## **MEMORANDUM**

**SUBJECT:** SCOPING NOTICE FOR THE PLEASANT VIEW WATER MAIN INTERCONNECTION PROJECT,  
NEW MILFORD, CT

**TO:** LINDA BRUNZA  
THE DEPARTMENT OF ENERGY AND ENVIRONMENTAL PROTECTION (DEEP)

**FROM:** JAMES DABBO  
SNYDER CIVIL ENGINEERING, LLC

TOWN FARM BROOK CROSSING SHEETS

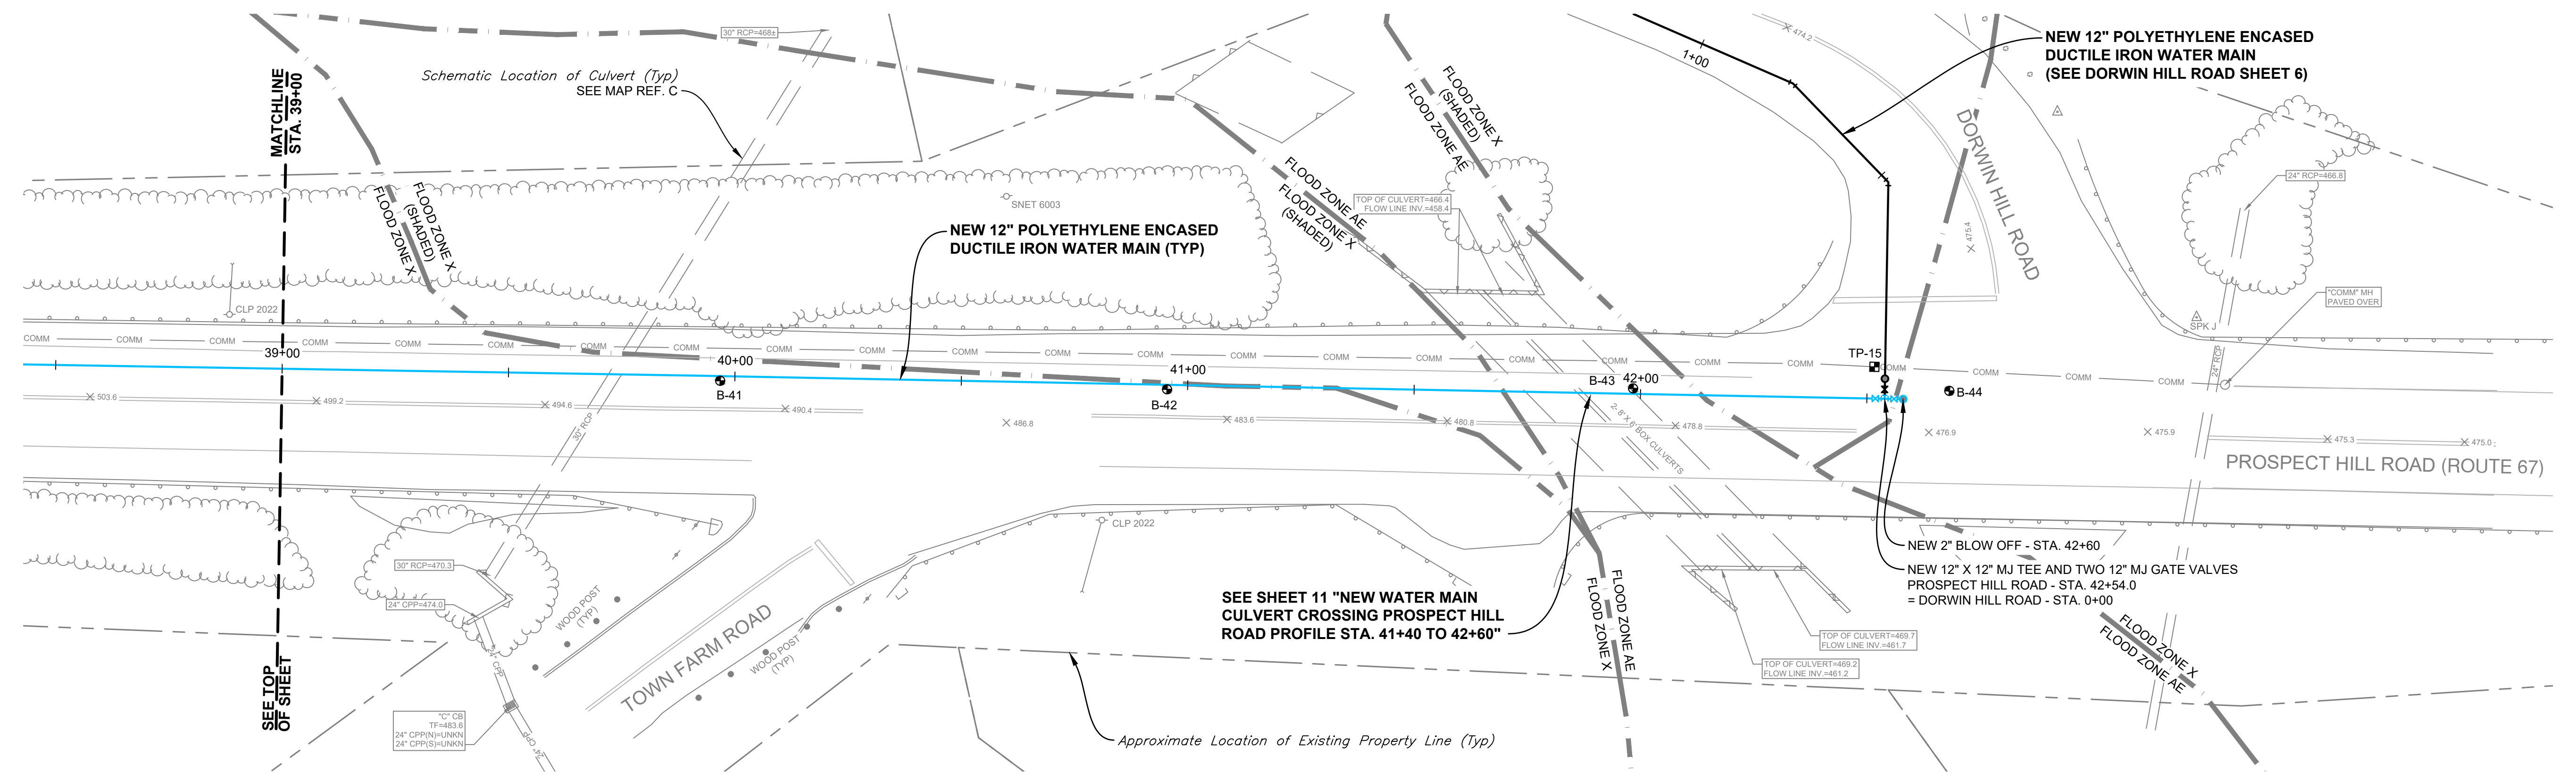
*DEEP's Fisheries Division has reviewed the scoping notice for any disturbances to waterbodies. The project crosses Town Farm Brook, a cold-water tributary to Lake Lillinonah. Since the project is in the early stages and there are no detailed plans to review, Fisheries stated that any concerns will be addressed by the implementation of proper erosion and sediment controls throughout the duration of this project. Any unconfined instream work, if required, should be restricted to the period from June 1 to September 30. Please contact Shalyn Zappulla with any questions at [Shalyn.Zappulla@ct.gov](mailto:Shalyn.Zappulla@ct.gov).*

*From the project description and without plans to review, it appears that the pipe will be placed in or under the streambed, or potentially impacting wetlands in the area along the water line corridor.*

*This comment has been noted. The installation will be within the limits of existing paved roadway CT State Route 67. At this location, the Town Farm Brook crosses the road through a culvert that is approximately 13 feet below the roadway surface. Top of the new water main will be buried approximately 4.5 feet below the roadway and the bottom of the new water main will be approximately 7 feet above the top of the culvert. Please see "Attachment A."*

*This comment has been noted. Please see above response to Fisheries Division comments for details.*
